GOVERNMENT OF THE DISTRICT OF COLUMBIA
DEPARTMENT OF TRANSPORTATION

MEMORANDUM

SUBJECT: BZA Case #18506, 1700 Columbia Road, NW

Figure 1: Proposed Site Layout and Access.

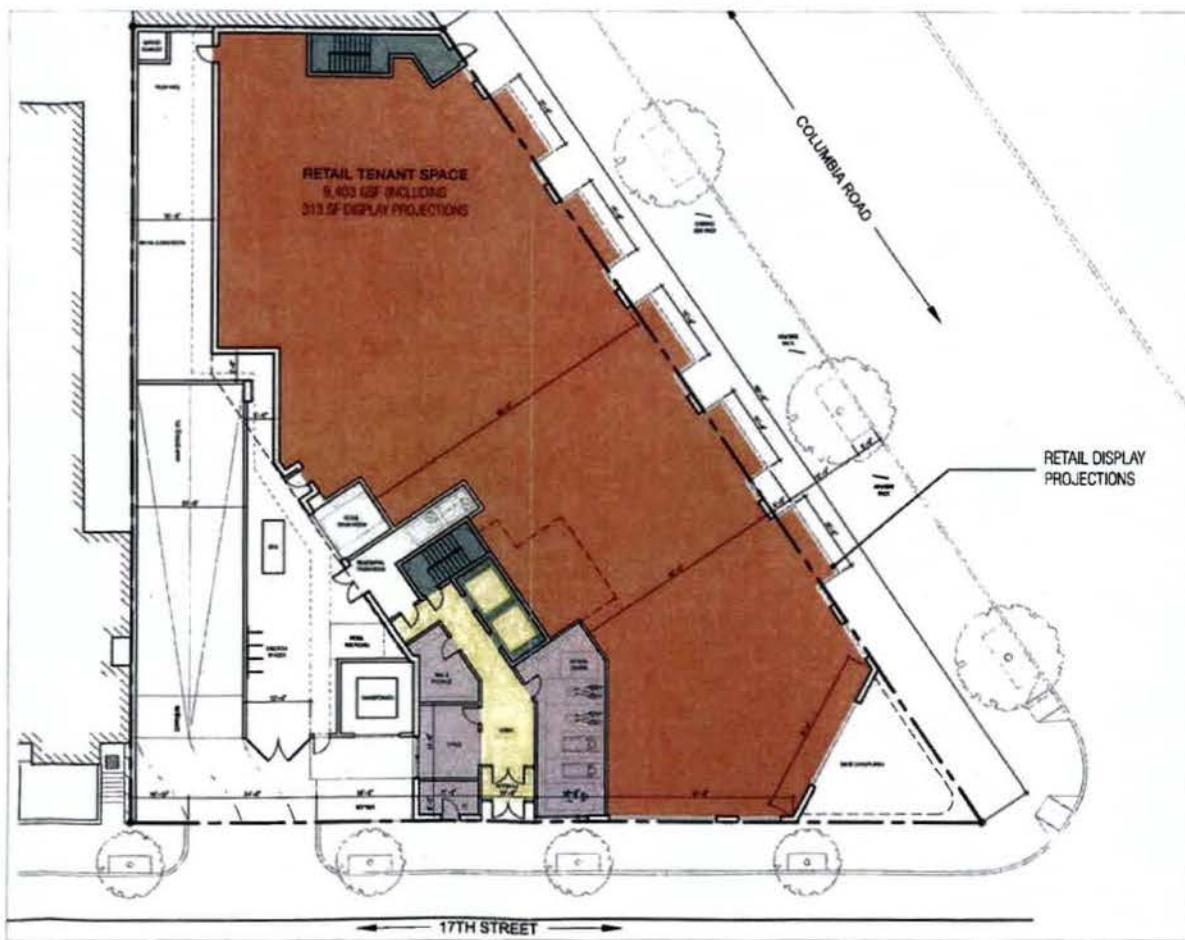
As shown in Figure 1, a curb cut is proposed on 17th Street for vehicle access to below-grade residential parking. This access also serves long-term bike parking as well. Pedestrian access to retail is from the sidewalk frontage along 17th Street and along Columbia Road. Pedestrian access to the residential units is via the ground floor lobby.

DDOT notes that the proposed 24' curb cut along 17th Street may be a residual design from a prior site plan that incorporated loading *on-site*. DDOT's preferred driveway width is 20 feet which coincides with the DDOT minimum for two-way vehicle traffic. While the curb cut is subject to the Public Space permitting process, DDOT notes that the given the proximity of the Site to a school and the high pedestrian activity in the area, the narrower curb cut is needed to reduce the speeds of vehicles as they ingress and egress across the sidewalk, and will not adversely impact the operations of the project.

- Secure private bike parking is increased to 1 space per 2 residential units. Bike parking is currently offered at a ratio of approximately one space per 3 units, however as shown in this report, the biking demand is very high for this area of the District.
- The proposed curb cut along 17th Street should be designed such that the driveway width does not exceed 20 feet, the DDOT commercial minimum for 2-way travel, with curb return radii not

to exceed 6 feet. The narrower curb cut will serve the site's occupants and will reduce the risk of pedestrian conflicts in the public space. The need is even more critical in light of the adjacent elementary school on 17th Street.
